TE Connectivity

Product Change Notification: PCN-23-175092
Customer: RS Components (1271907) Location: Northans PCN Date: 15-MAY-23
Agreement: Agreement Unknown

General Product Description: (Text limited to 120 characters)
RE series relay Cover color Change

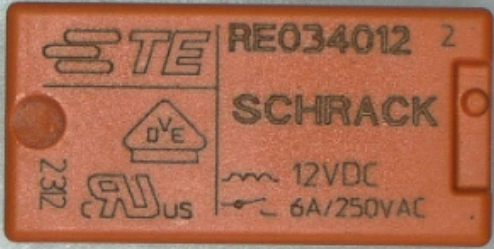
The following part numbers are being modified by changing the outside cover color from orange to natural. While both materials have the same characteristics, the same tests according to UL and VDE are passed. The Relay form (dimensions), features and ratings keep unchanged.

Cover color before change

Cover color after change
